MARYLAND
LAKE WHETSTONE

NDI ID NO. MD-53

PHASE I INSPECTION REPORT
NATIONAL DAM INSPECTION PROGRAM

By
RUMMEL, KLEPPER & KAHL
Consulting Engineers
Baltimore, Maryland 21202

PLATE A-1

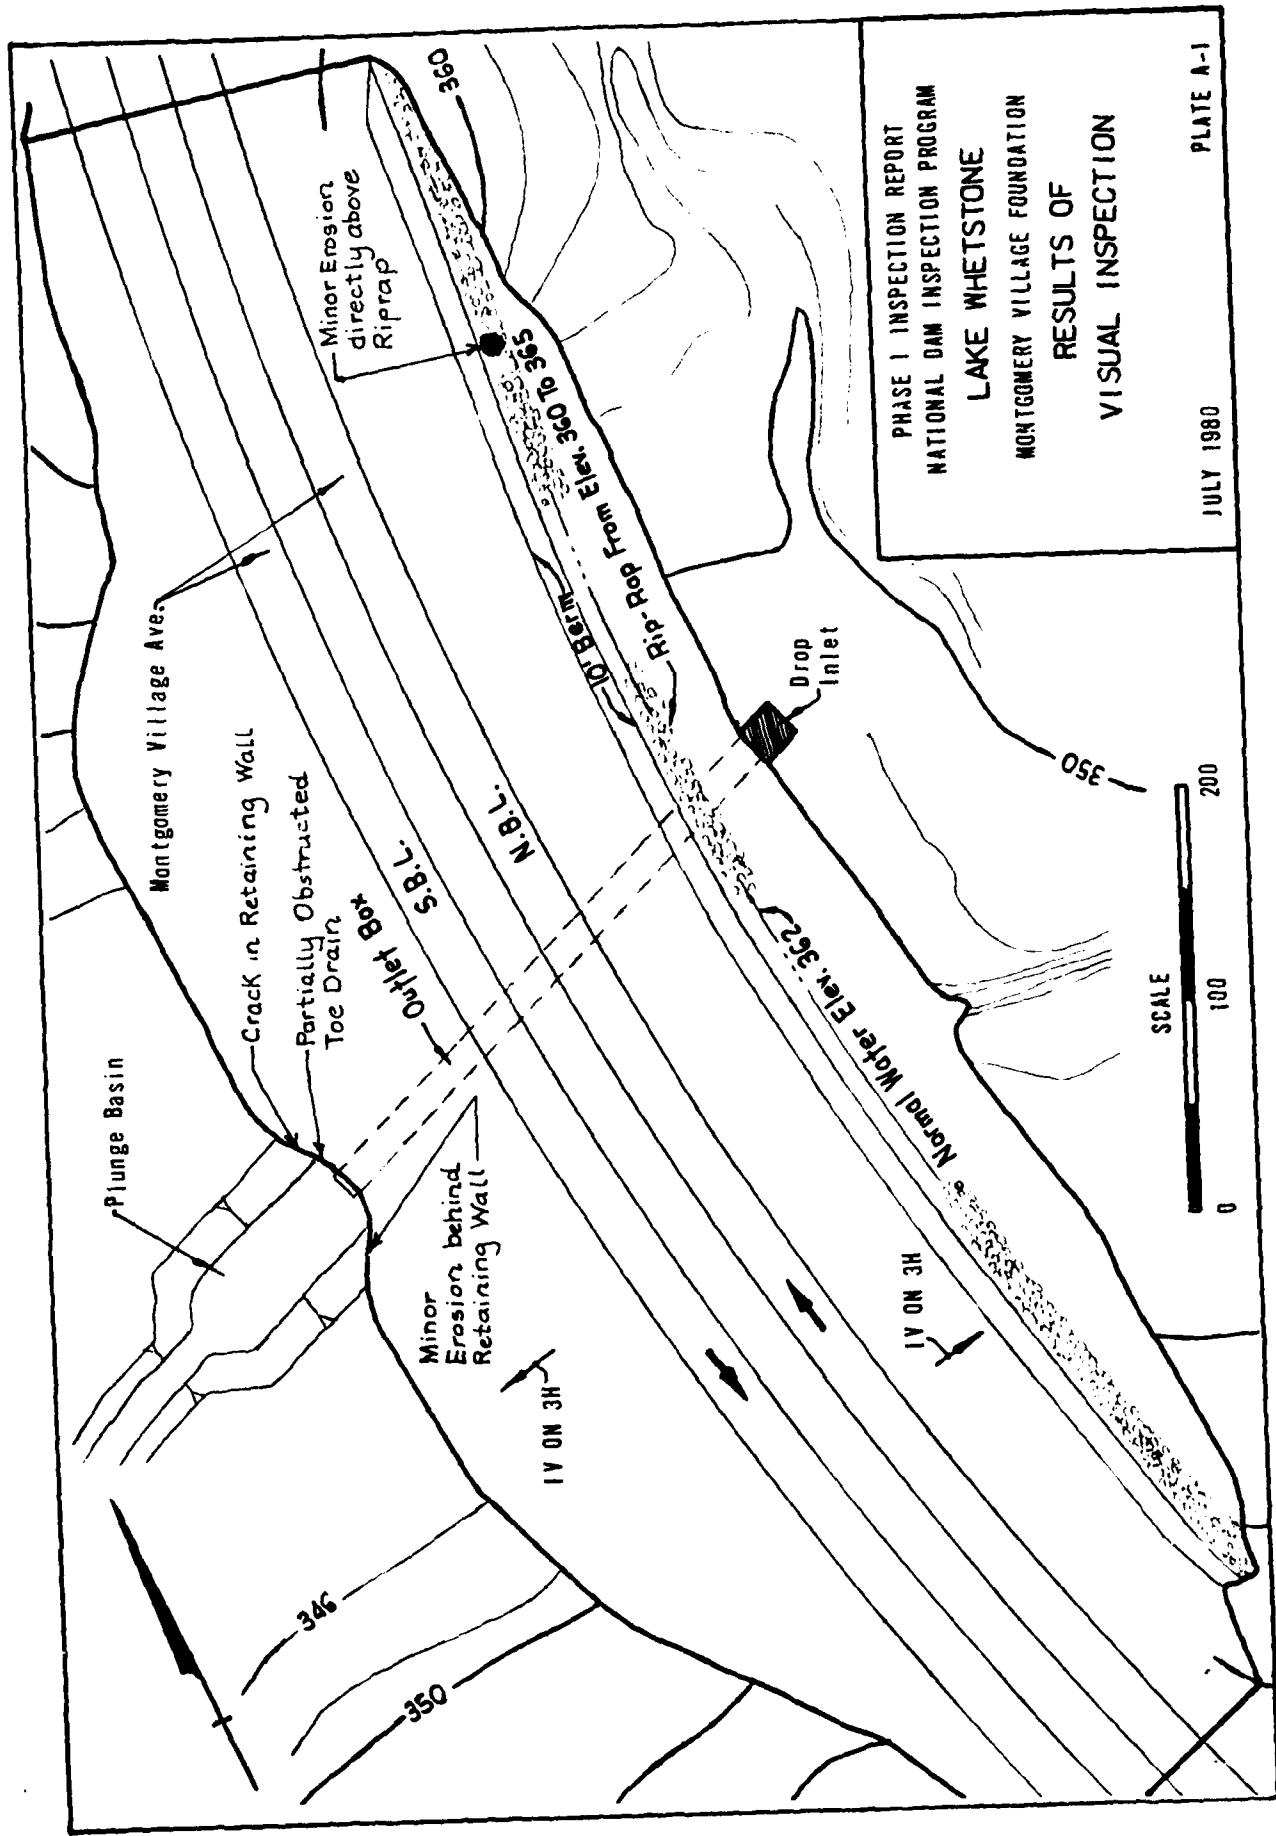
The specific observations are shown on Plate A-1.

H. Erosion behind left wingwall of outlet structure

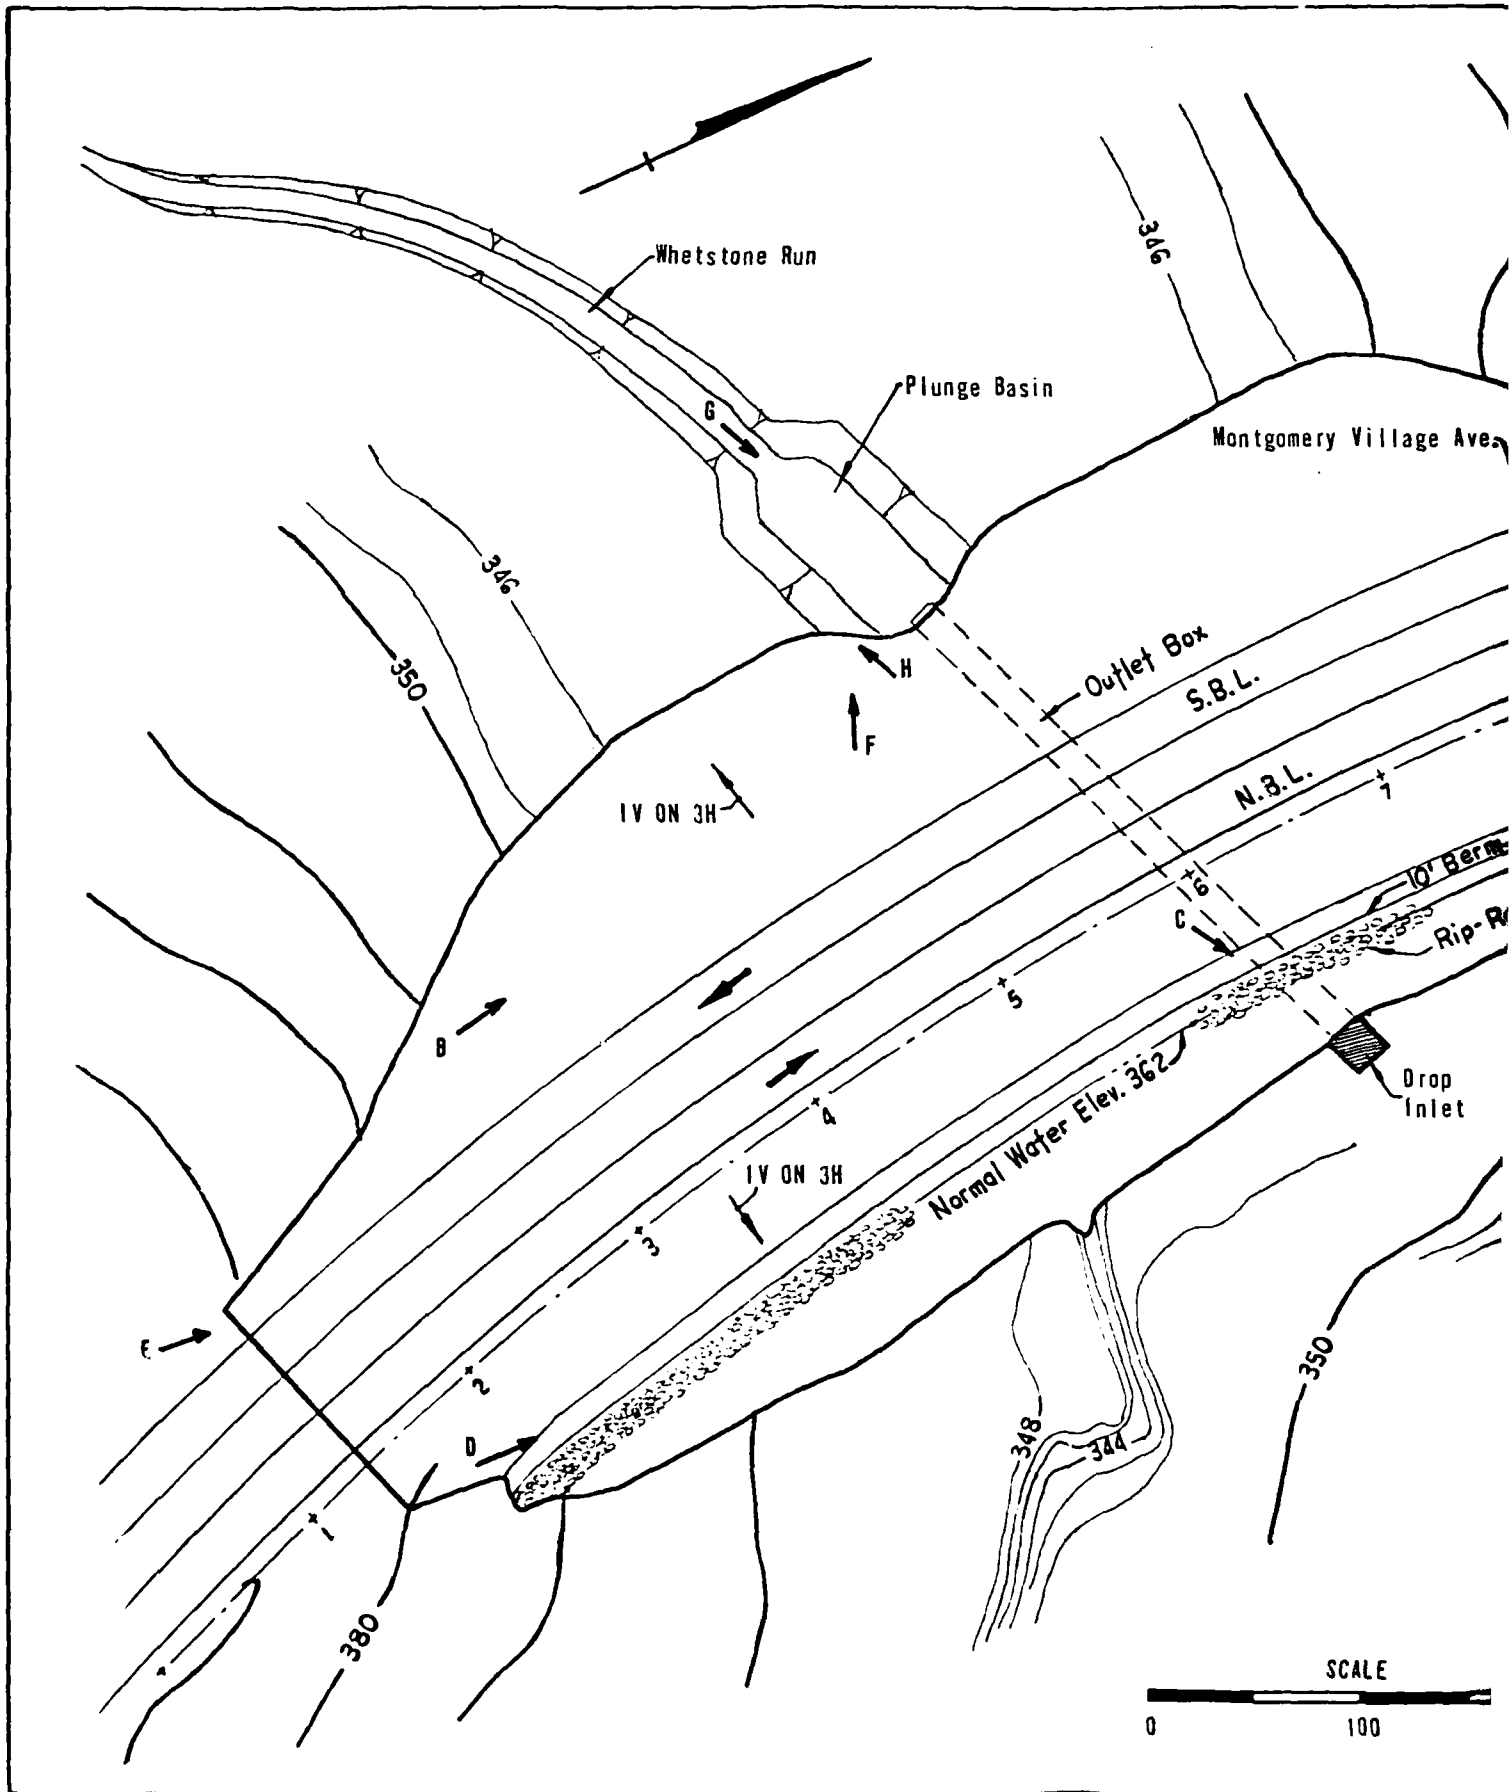
- (1) Embankment. Visual examination of the dam embankment indicates that there are no wet spots, seepage, slumps or other features that suggest embankment instability.
- (2) Appurtenant Structures: A structural crack was noted across the right headwall of the outlet structure. Erosion was noted behind the left wingwall of the outlet structure.

- a. Repair the structural crack on the face of the north headwall of the outlet structure.
- b. Remove the corrosive build-up which is partially obstructing the northern toe drain outlet.
- c. Repair the erosion behind the south wingwall of the outlet structure.
- d. Inspect the chamber of the drop inlet spillway to determine if there is a blockage to the left side of the twin box culvert, and remove any obstructions which exist.
- e. Schedule formal periodic inspections of the dam embankment and appurtenant structures.
- f. Develop a formal warning system to alert downstream residents in the event of emergencies.

PLATE C-2

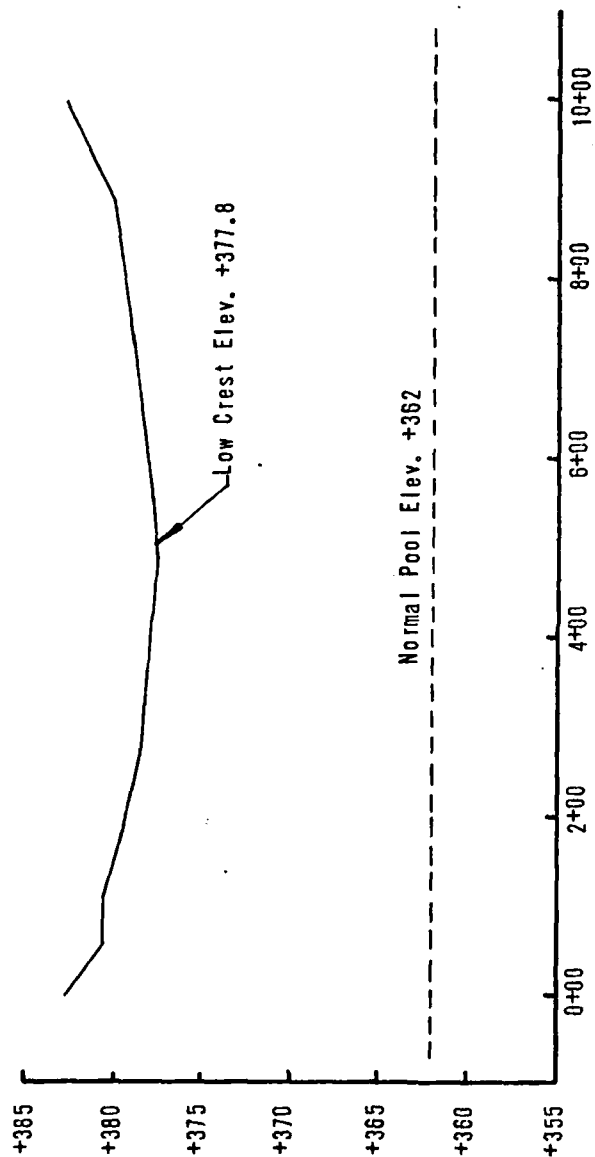
The crest of the dam was surveyed and the variance in elevation was 5 feet between the high and low point. This variance is due to the vertical curve of the roadway across the dam crest. The low point on the crest is approximately 8 inches below the design crest elevation of 378.5, and is located 50+ feet left of the intersection of the twin box culverts of the spillway and the embankment. Freeboard at the time of inspection was approximately 16 feet, and under maximum pool (i.e. design flood) conditions would be approximately 3.5 feet. The dam crest profile is included as Plate C-2.

- (1) Embankment. The survey of the dam crest profile performed during the visual inspection indicates that the existing crest is slightly lower than its design elevation of 378.5 feet above m.s.l., with its low point at elevation 377.8 feet above m.s.l. The elevation data for the existing crest was employed in subsequent hydraulic analyses.
